Ground Floor Flat
5 Hillfield Road
London NW6 1QD

Re: Planning Reference 2021/2596/P

**Description: Site R/0 1 Hillfield Road NW6 – OBJECTION TO APP 2021/2596/P
OBJECTION BY 5 HILLFIELD ROAD – OVERSHADOWING ADDENDUM**

**Site Address: Land between Gondar House and South Mansions, Gondar
Gardens and to the rear of Hillfield Road, West Hampstead, London NW6 1QD.**

17.00, March 21st

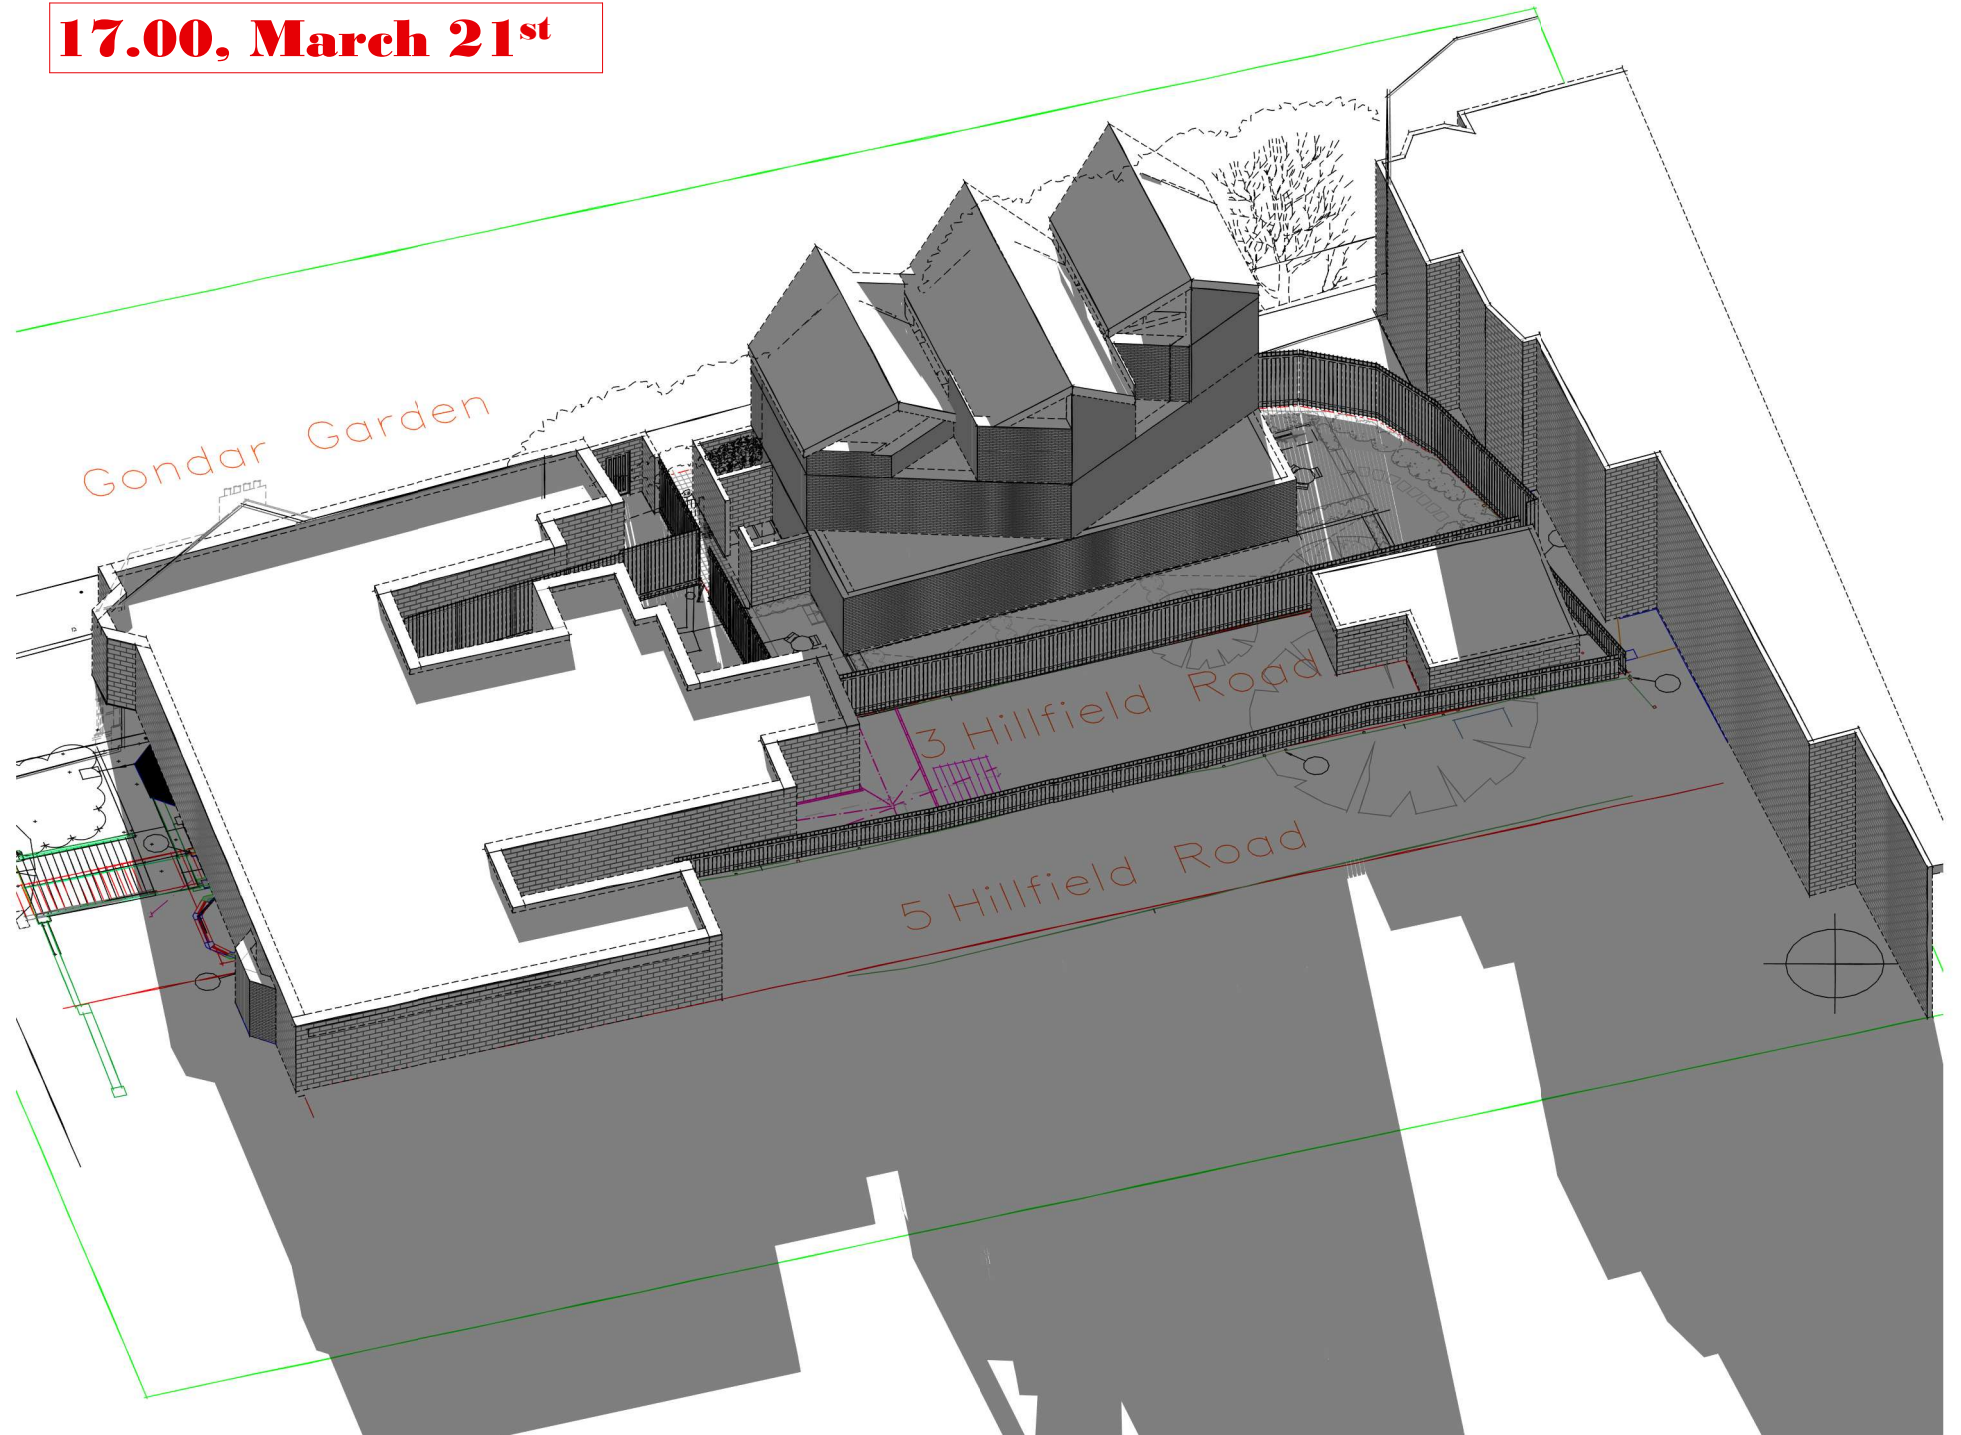
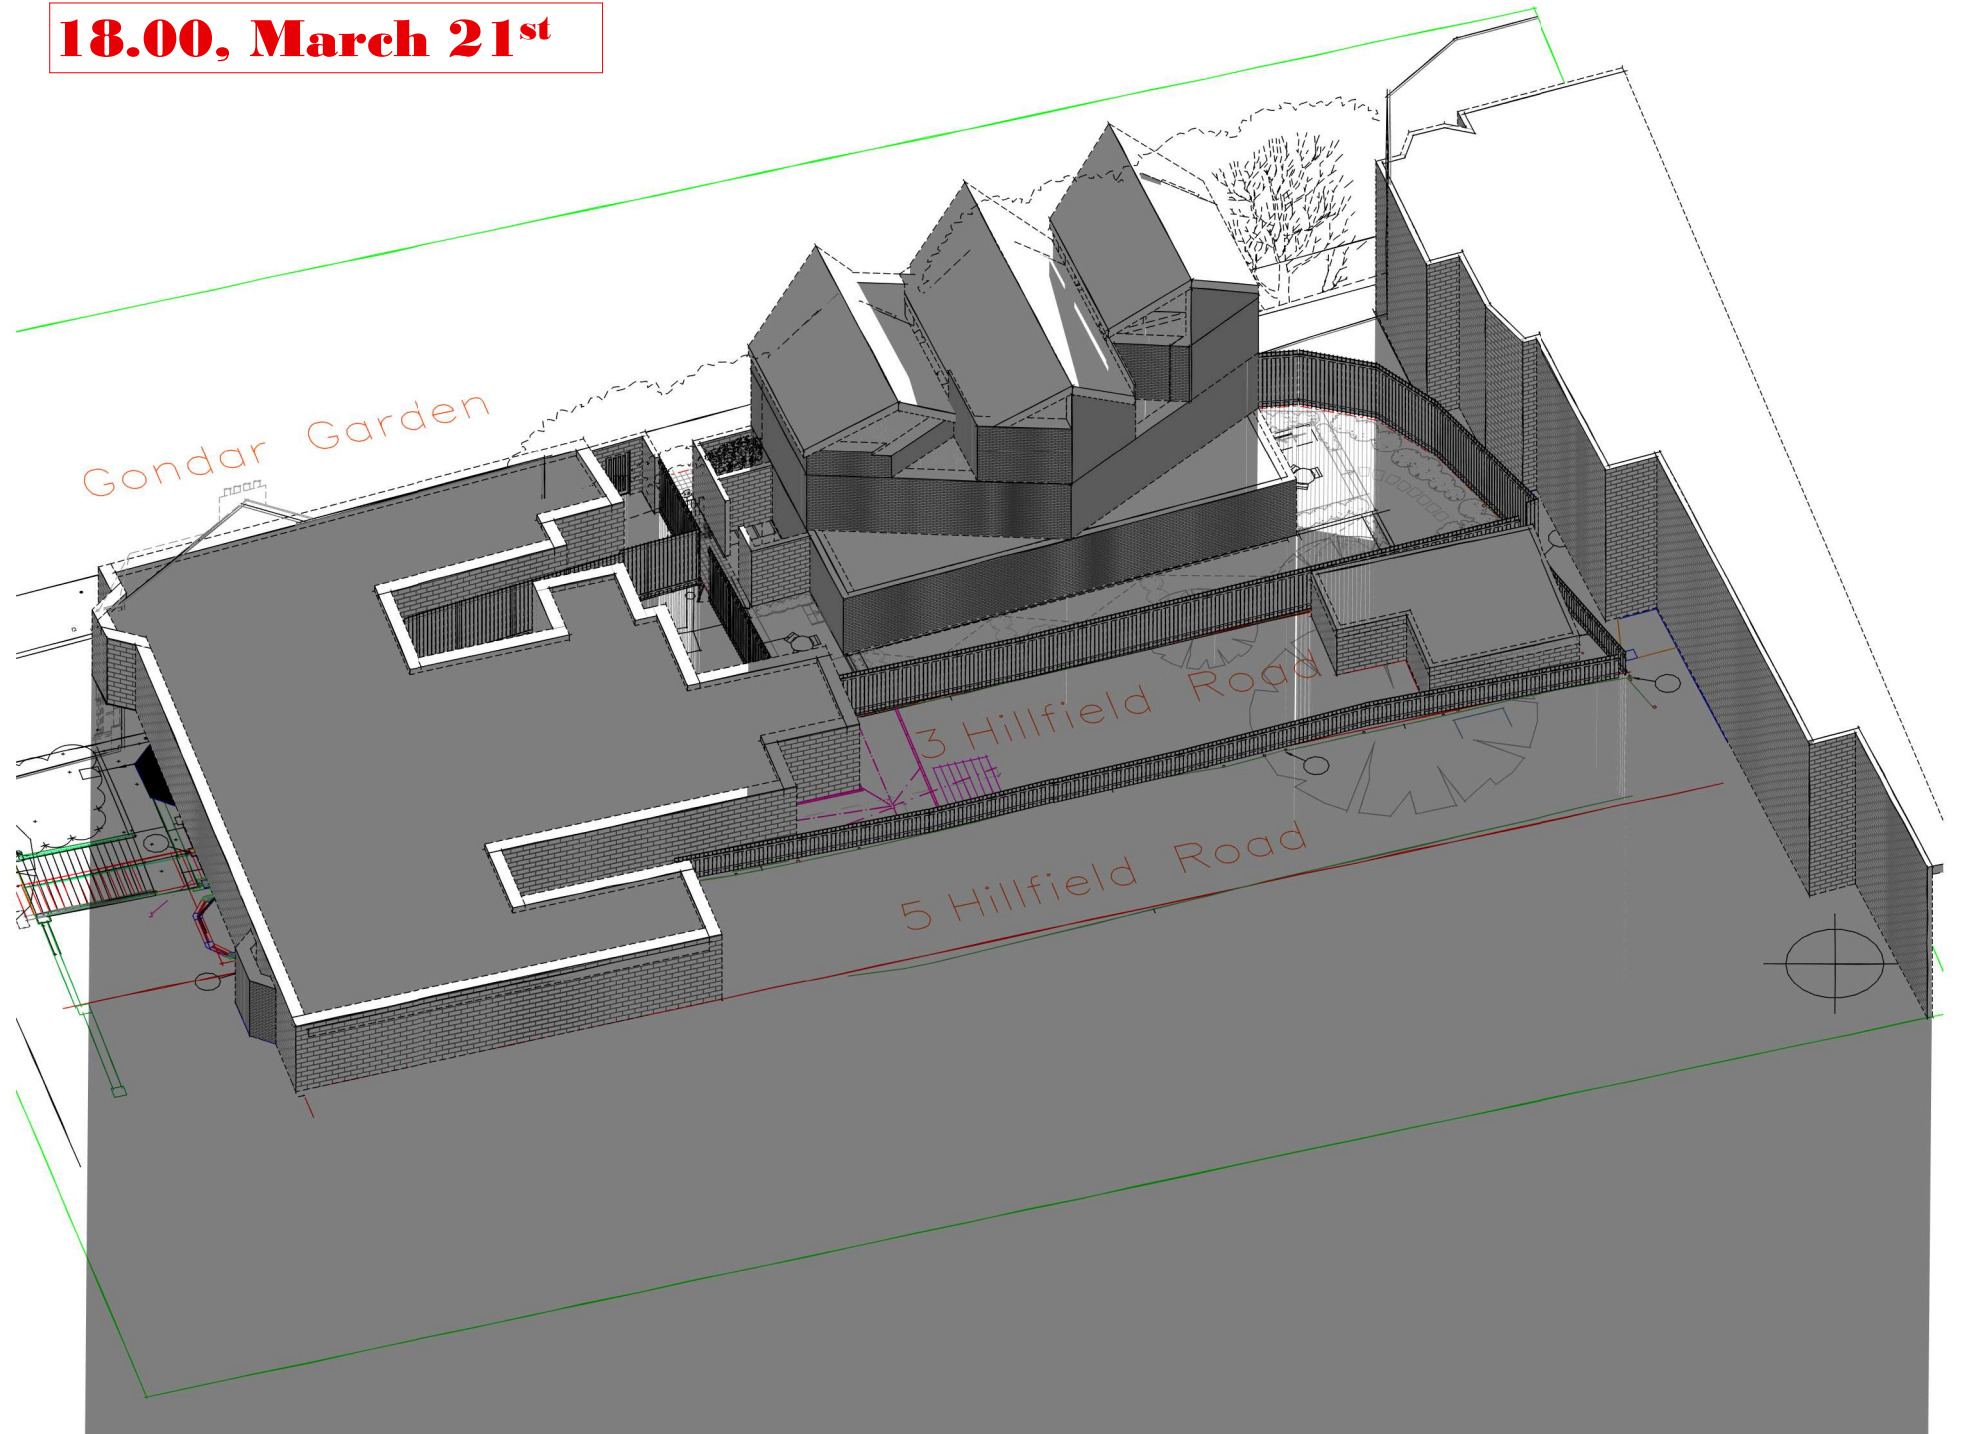
From the analysis we have carried out below the development clearly does not meet the criteria above and development sheer size blocks all the sunlight completely into the gardens of 3 and 5 Hillfield Road. It also affects 7 Hillfield Road.

Our own modelling has Gondar House only as ground floor as such the modelling does not show full height of the building and hence not the correct overshadowing on 1 Hillfield Road patio area which will be much worse than the current modelling. The modelling was done to show the extent of overshadowing on 3,5 & 7 Hillfield Road gardens. Also, our model below shows the overshadowing at 21 March. The model shows that the sun is blocked from 14:00 o'clock on 3 Hillfield Road and from 15:00 it is blocking 5 Hillfield Road, the overshadowing continues till sunset at 18:15. We went further to do analysis in June and the overshadowing continues till sunset at 21:00.
